RE: Response to TCEQ NOD 3 Addendum – CCR105
Luminant Generation Company LLC – Tatum, Rusk County
Industrial Solid Waste Registration No. 31277
EPA Identification No. TXD000821306
Tracking No. 27220868; RN102583093/CN603256413

Table 1 - NOD Summary and Response
Registration No. CCR105 - Luminant Generation Company LLC
Application Deficiencies - Addendum to NOD 3

RE: Response to TCEQ NOD 3 Addendum – CCR Registration No. CCR105
Martin Lake Steam Electric Station - Rusk and Panola Counties, Texas
(SWR 31277; RN102583093; CN603256413; EPA ID No. TXD000821306)

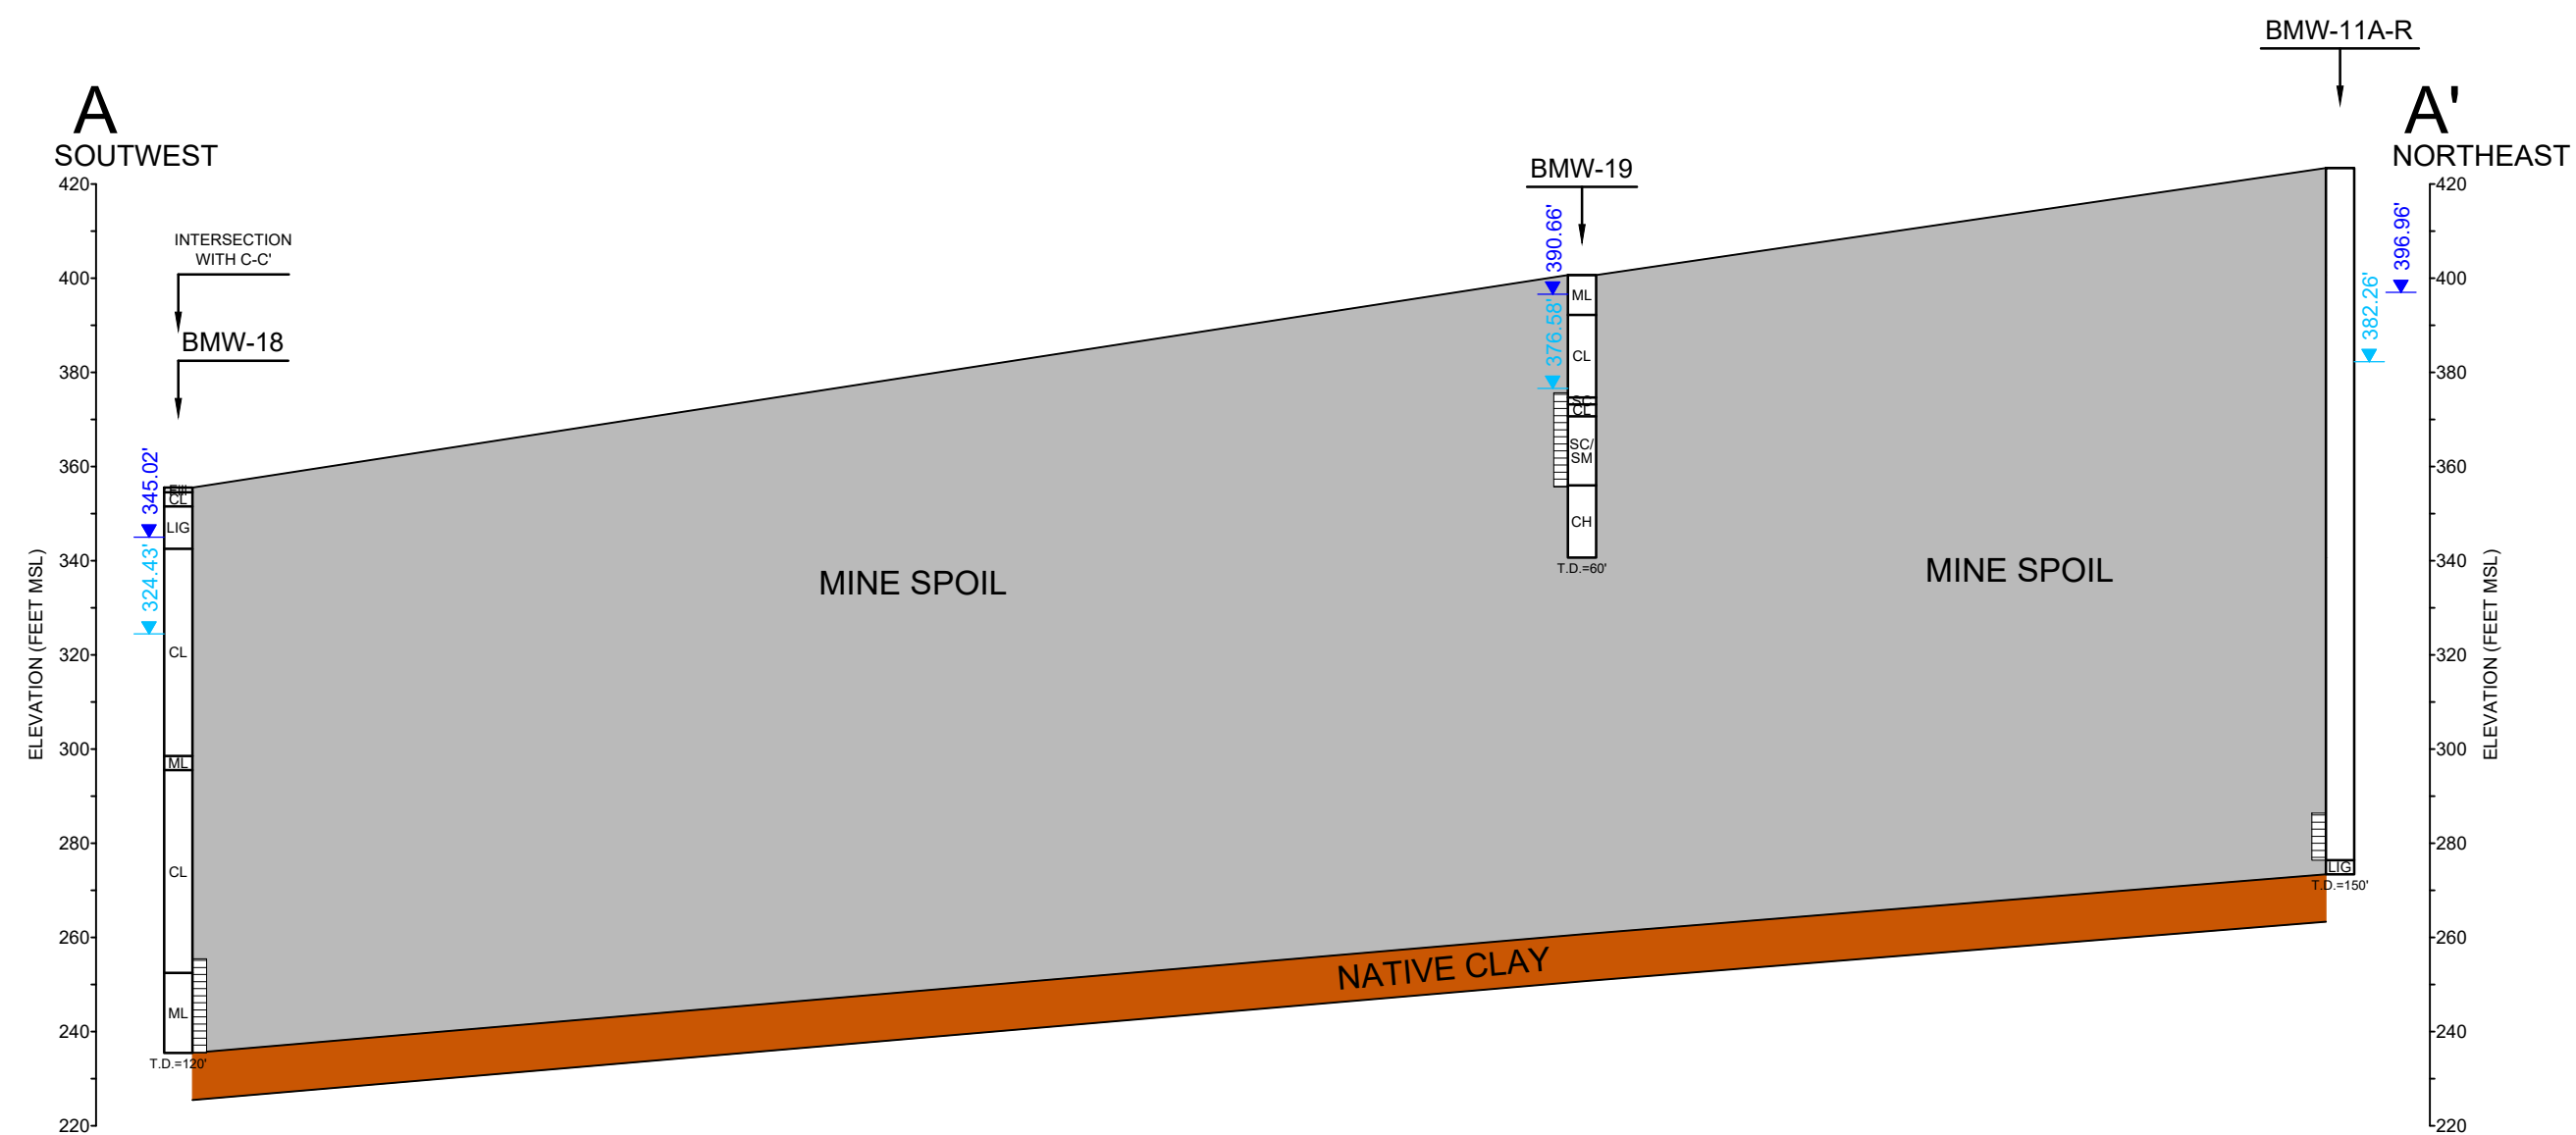
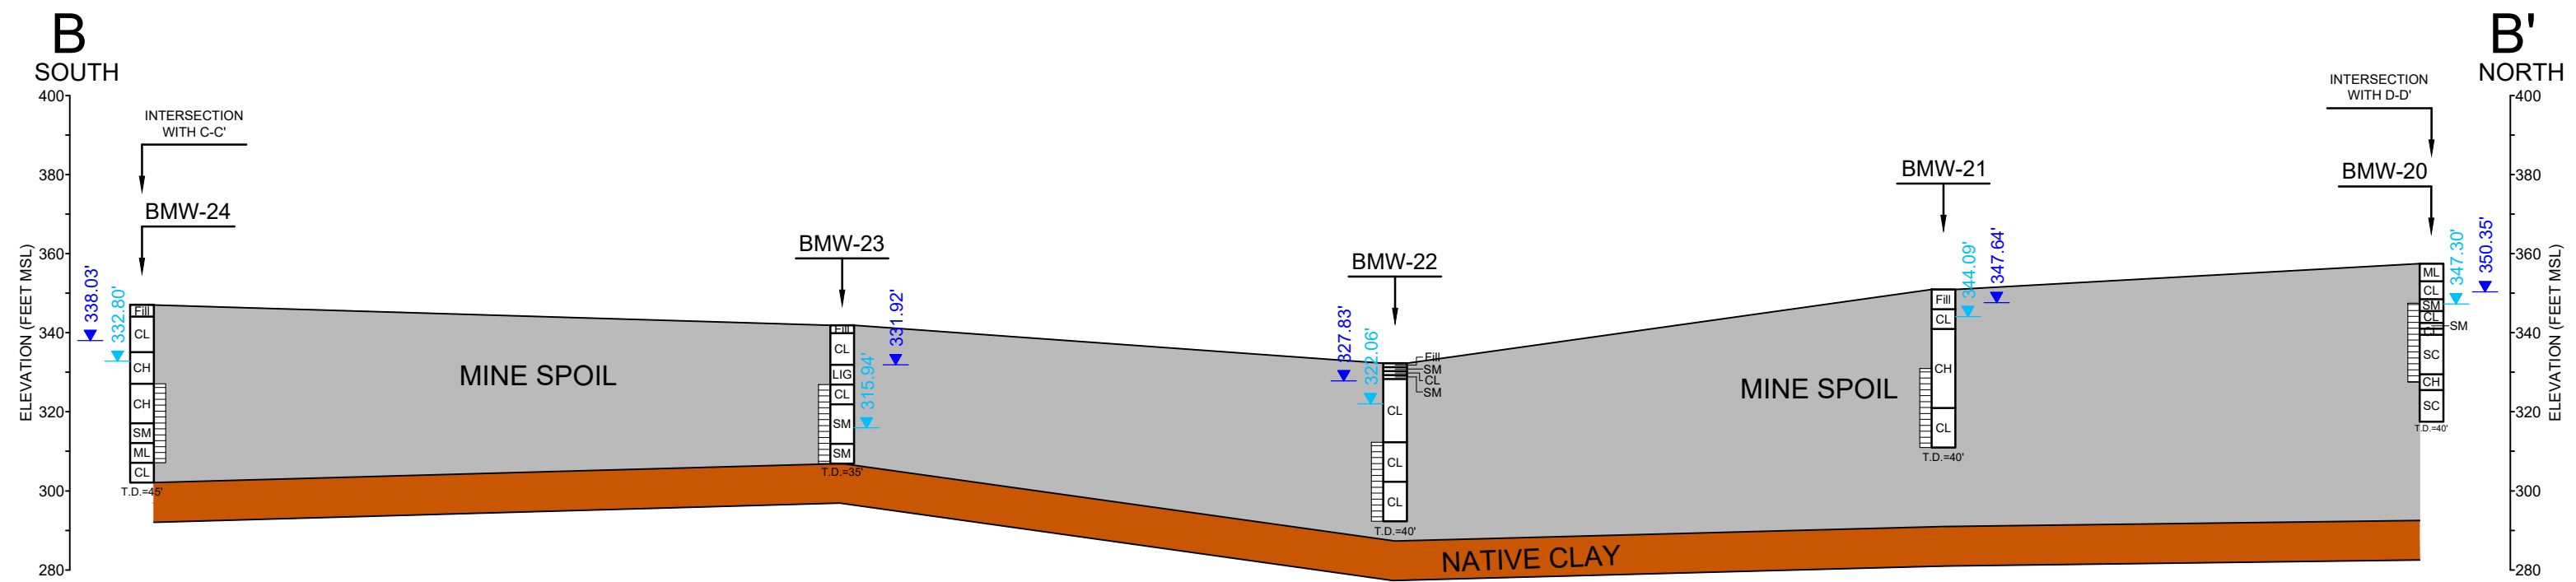
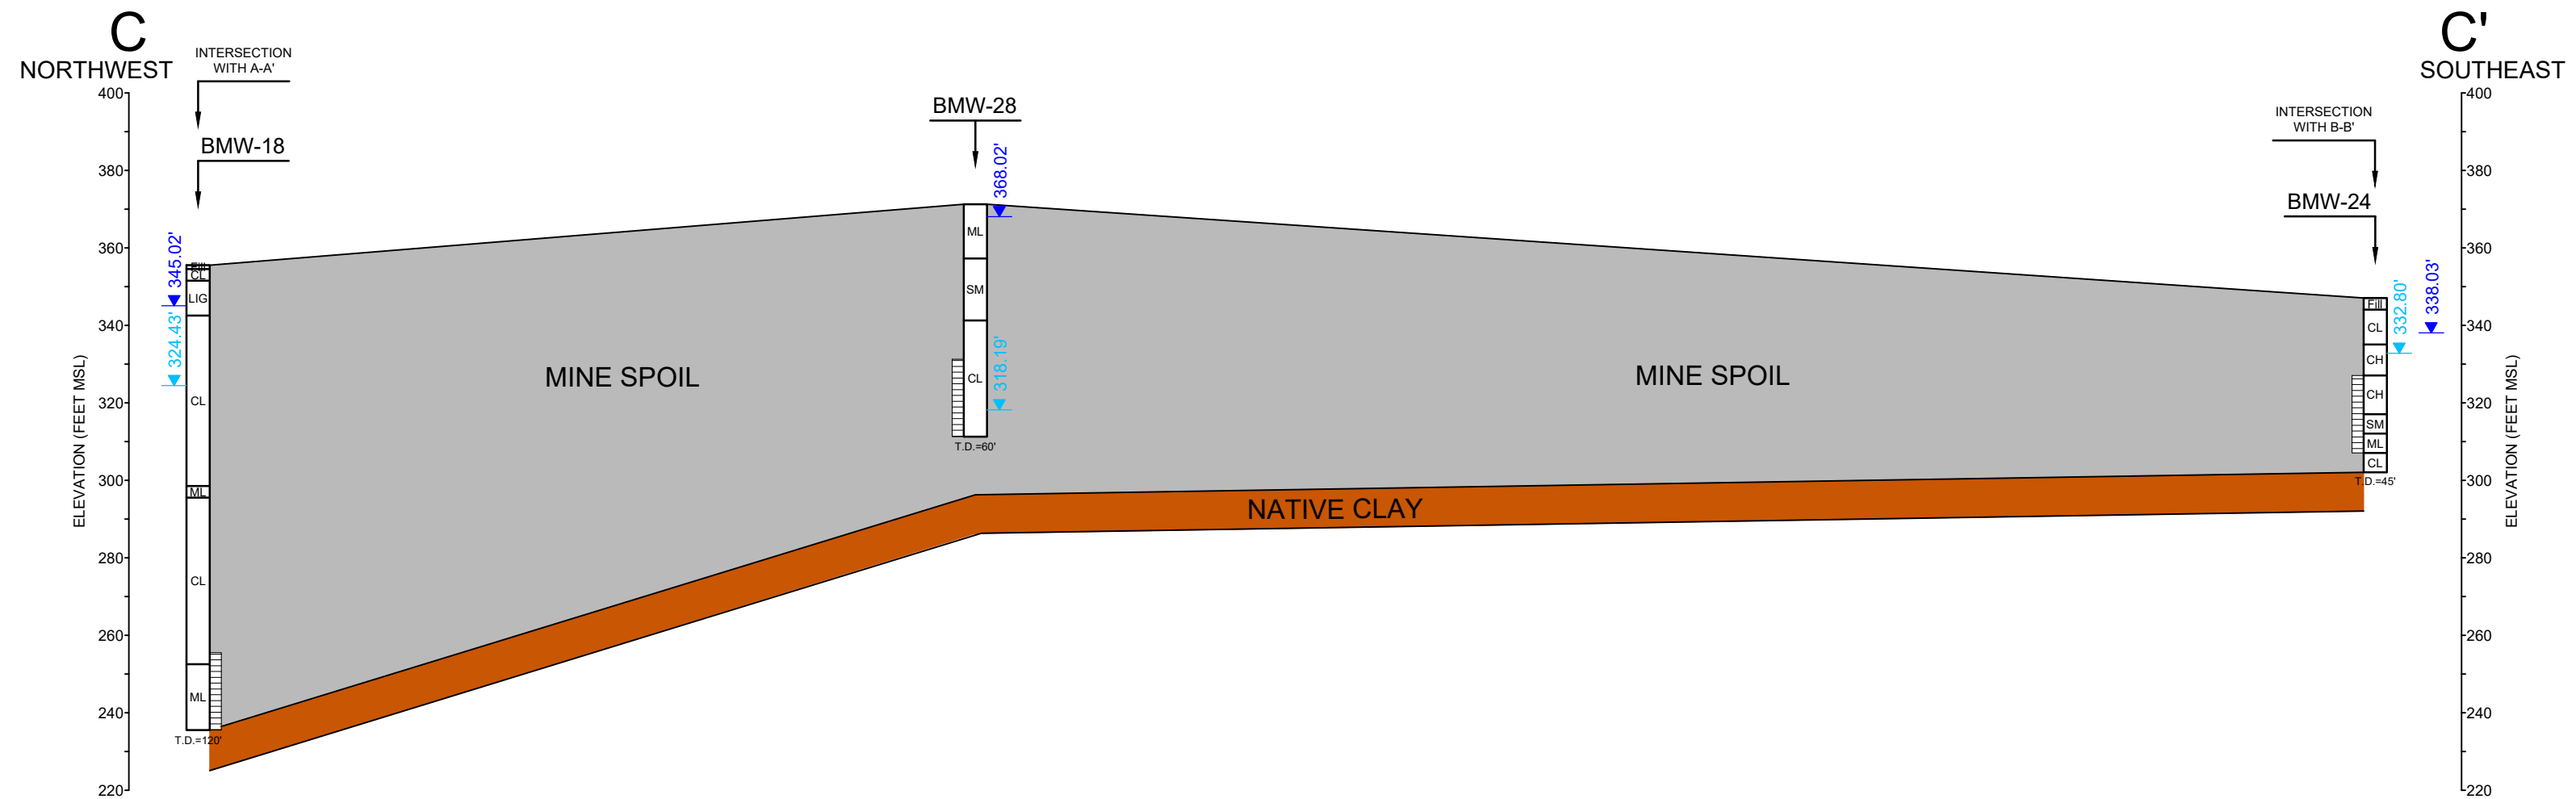
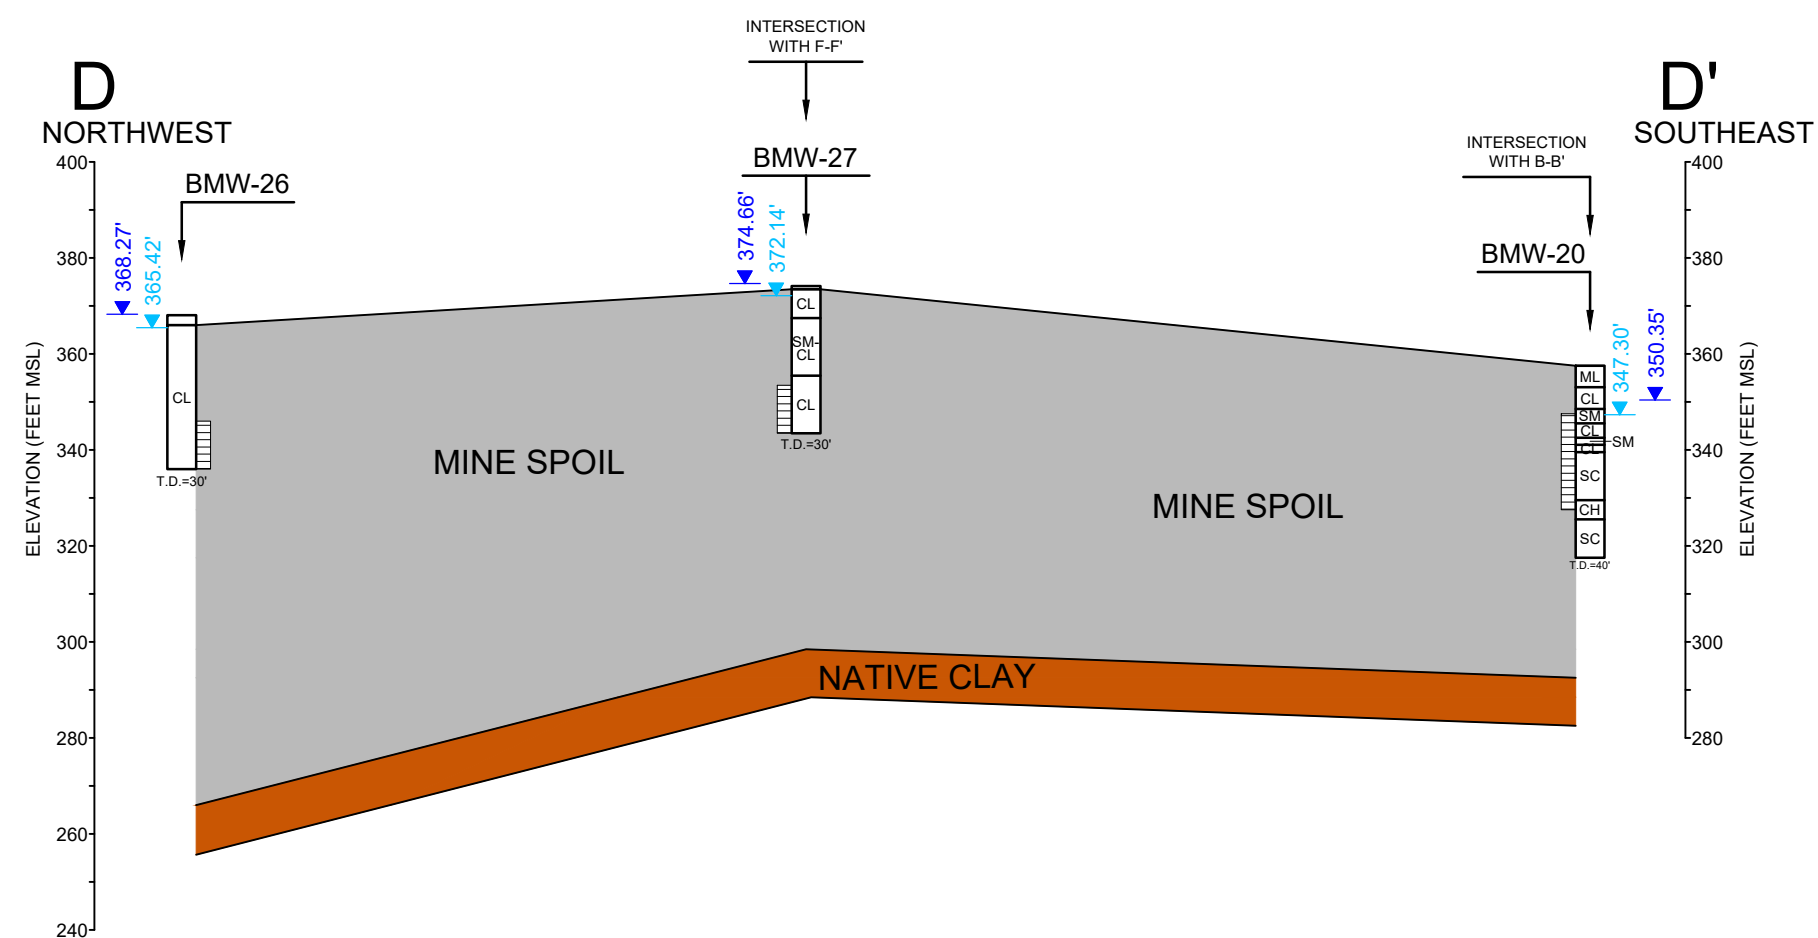
[A1 Landfill:] Provide North-South and East-West geological cross sections across the landfill down to the bedrock and beyond the boundary of the mine spoils showing the local subsurface geology in the vicinity of the landfill along with the projected nearest wells to the cross sections. Also, provide the maximum and minimum historical groundwater levels on the monitoring wells in the cross sections.

Response: The requested A1 Area Landfill cross sections are provided in Attachment 2.
